SAKURA NOVI JSP22-09

Public hearing at the request of Sakura Novi Land Development LLC for Planning Commission's recommendation to the City Council of Preliminary Site Plan, Phasing Plan, Wetland Permit, Woodland Permit, and Storm Water Management Plan. The subject property is zoned TC-1 with a Planned Rezoning Overlay (PRO), which conditions development to the terms of a PRO Plan and Agreement. The site is approximately 15 acres and is located north of Grand River Avenue, south of Eleven Mile Road, and east of Town Center Drive (Section 23). The applicant is proposing to develop a mixed-use development including commercial retail, office, and restaurant uses, and multifamily residential units. The development has access to Grand River Avenue and Eleven Mile Road.

PLANNING REVIEW

DRAWING NUMBER:
SHEET 6

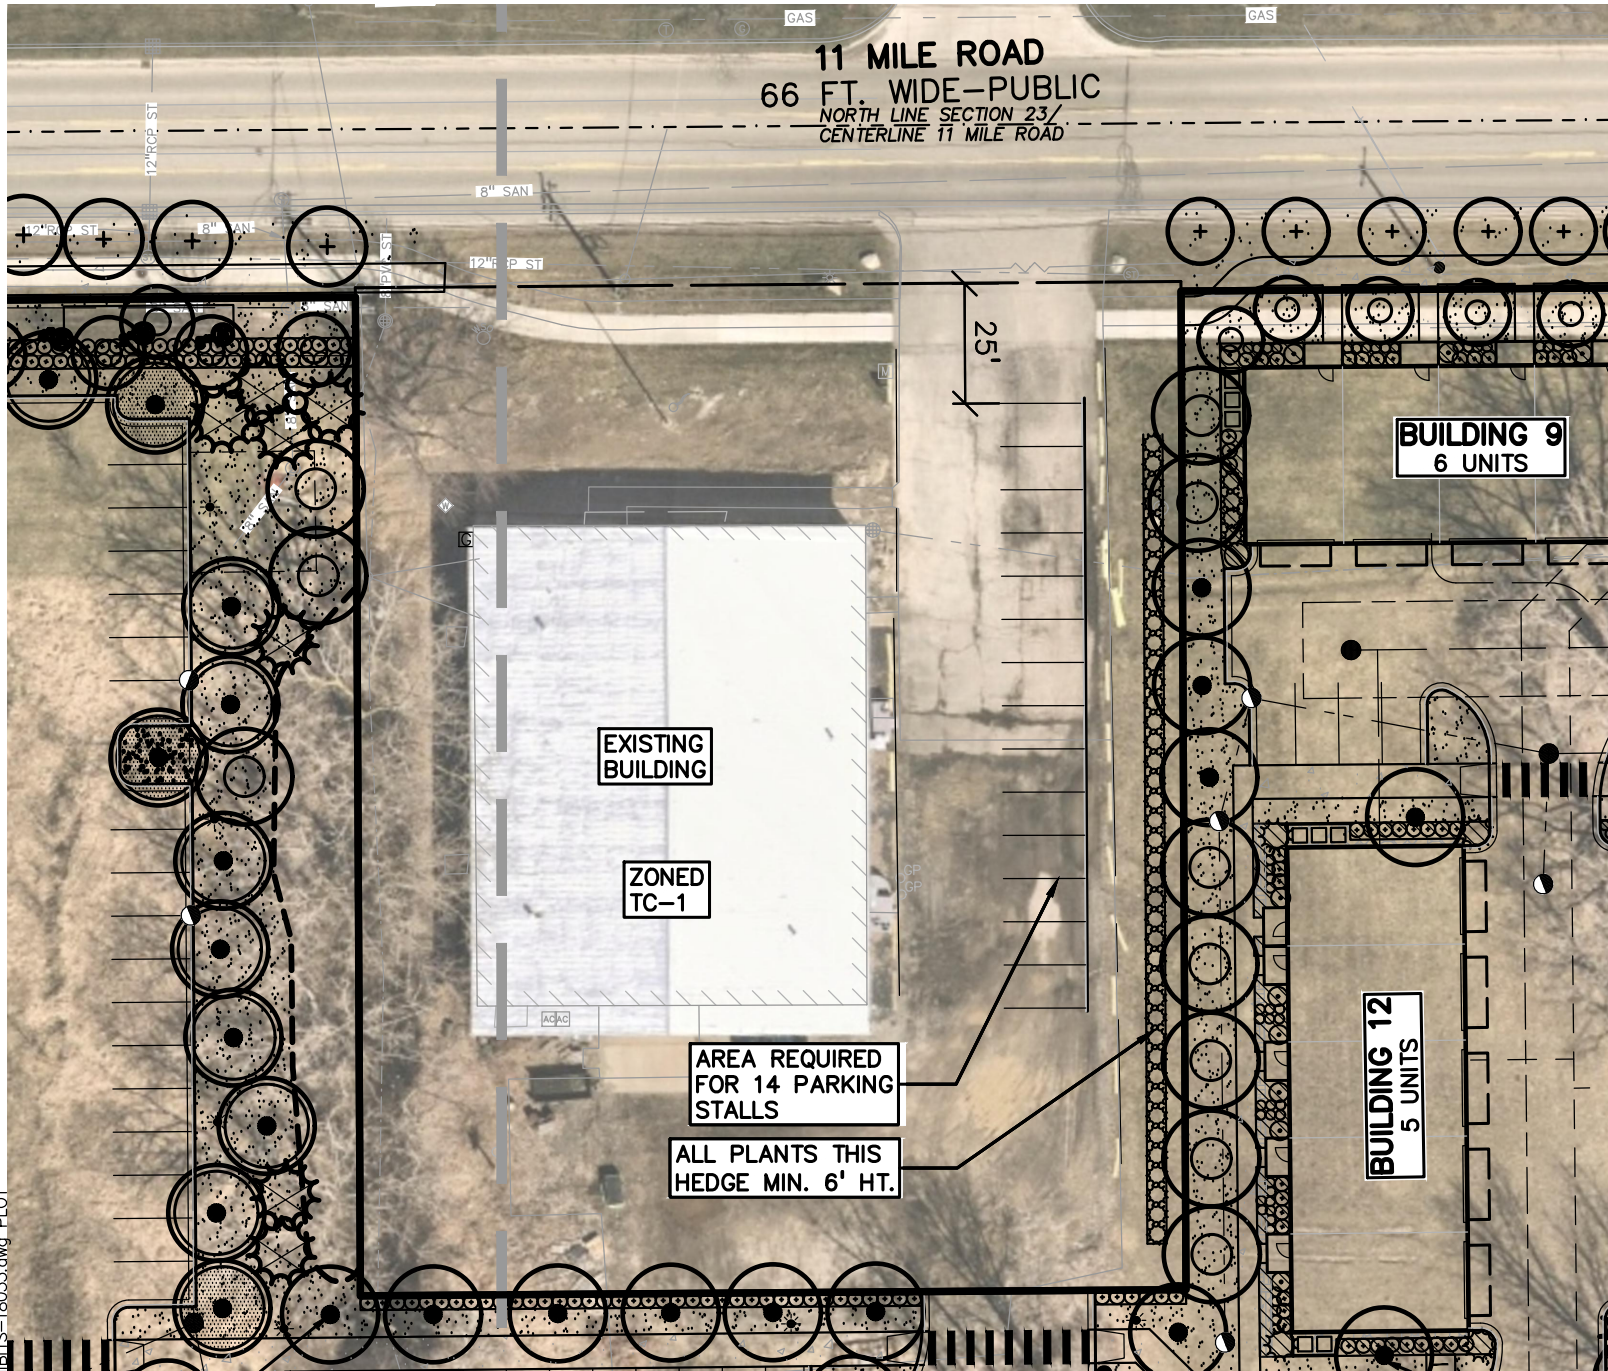
3. Recreational Amenities: In the PRO Agreement, the applicant had committed to providing a multi-generational recreational amenity in the area northwest of the pond, to be constructed concurrently with the adjacent residential units. There is a "pond platform" shown in the current plan set, and details of play area amenities are shown on sheet L-1.13. Landscaping sheet L-1.0 indicates "Sensory Garden Play Equipment" near the pond platform. However, the location for the play area amenities are not specifically shown on the civil sheets. There was also to be an Observation Plaza in the eastern area overlooking the stormwater/wetland area. Landscaping sheet L-1.0 shows a "Pond Overlook" in this location, however no seating is shown. **Please indicate the missing amenities on the civil sheets and provide additional details of the pond platform structure as well. These amenities will need to be shown with detailed plans in the Final Site Plan submittal.**

Observation Plaza detail is included – see **Attachment Sheet 6**. Pond platform draft detail is included – see **Attachment Sheet 2**.

This comment will be addressed at Final Site Plan Submission – see **Attachment Sheet 6** for omitted information.

SHEET 7-2

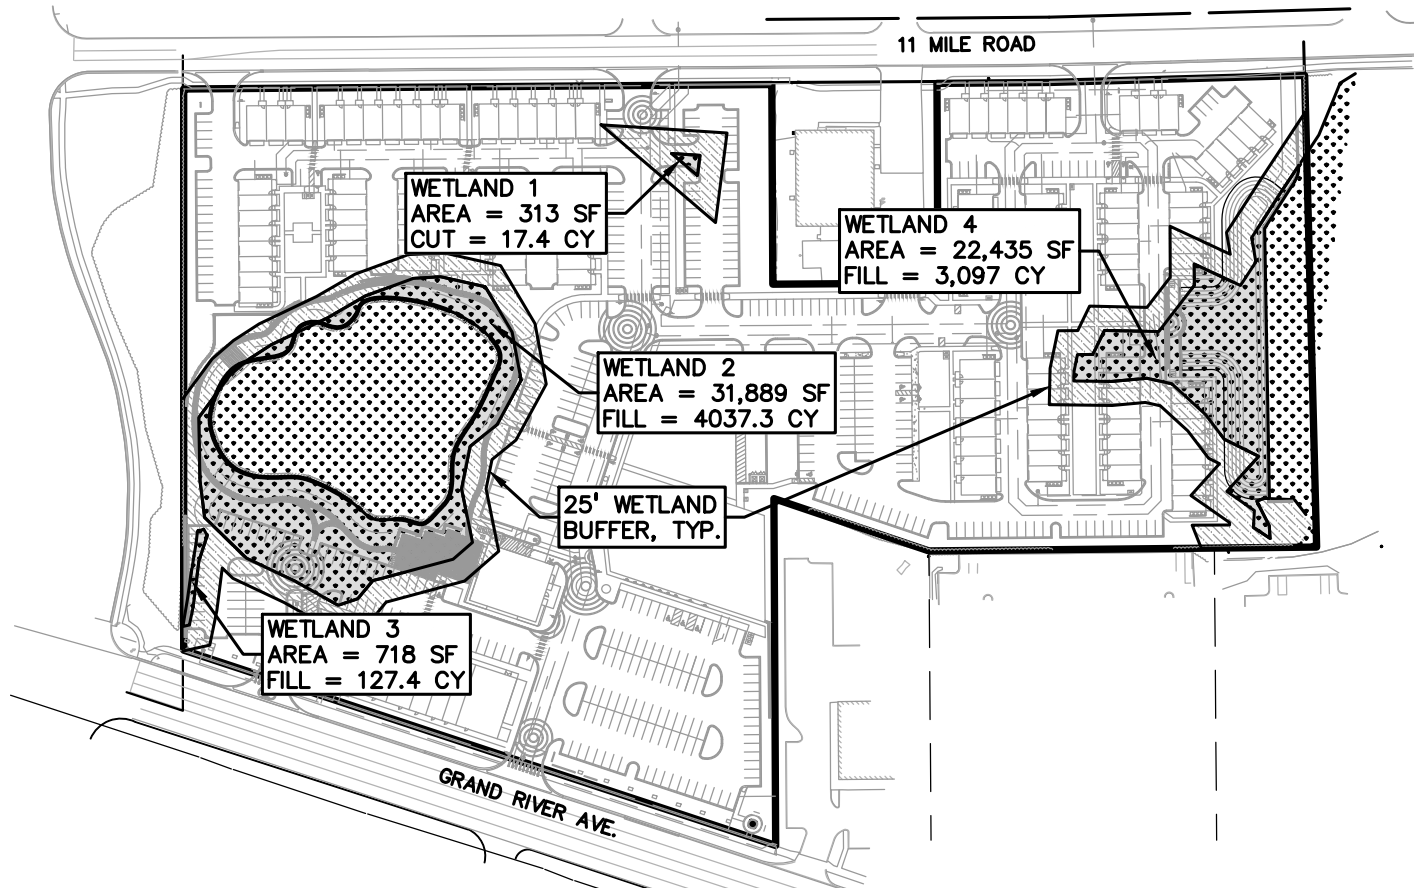
- The area of buffer impact was not quantified on the site plans,
- The area and volume of wetland fill were not quantified on the site plans, and
- The Wetland Edge seed mix list provided on Sheet L1.12 of the rPSP was illegible.

See **Attachment Sheet 8-1** for wetland fill area and volume calculations. See **Attachment Sheet 8-2** for seed mix information.

See **Attachment Sheet 8-1** for buffer impact areas (note PRO deviation has been granted to eliminate these setback area requirements), wetland fill area and volume calculations. See **Attachment Sheet 8-2** for seed mix information clarification.

DRAWING TITLE
**SITE PLAN
EXHIBIT -
PARKING CHART**

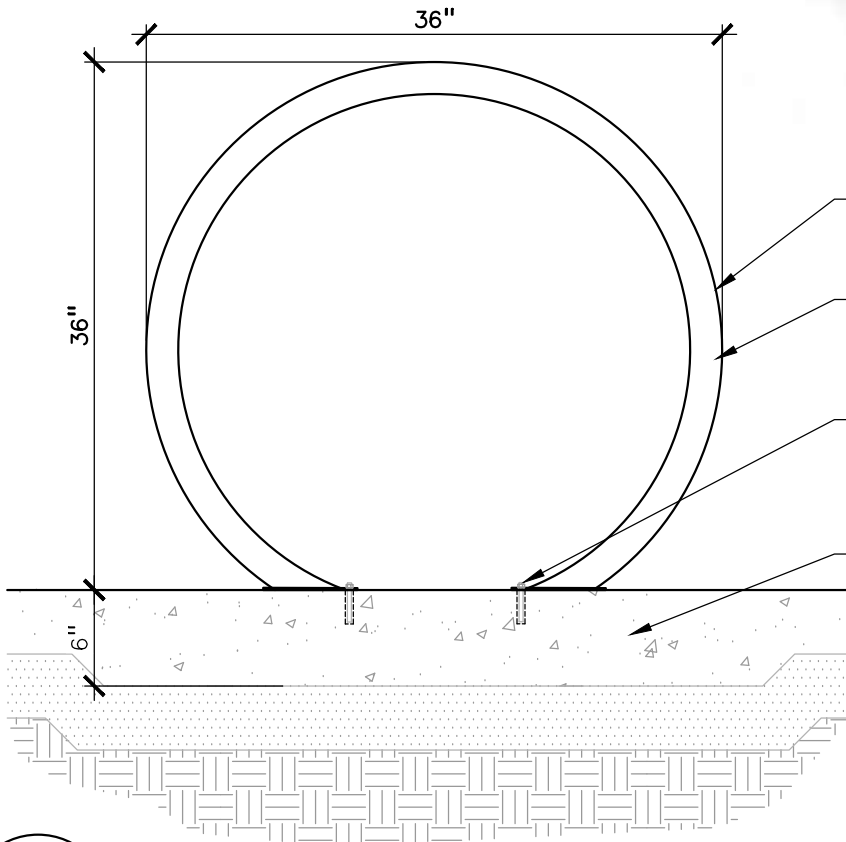
Sheet C-2.0 indicates 92 parking spaces in Phase 2 – unclear where those are located

This parking chart correction will be made at the time of Final Site Plan submission. The parking study uses all correct parking quantities as shown on site for the Phase 1 analysis. Corrected Parking Chart included as **Attachment Sheet 9**.
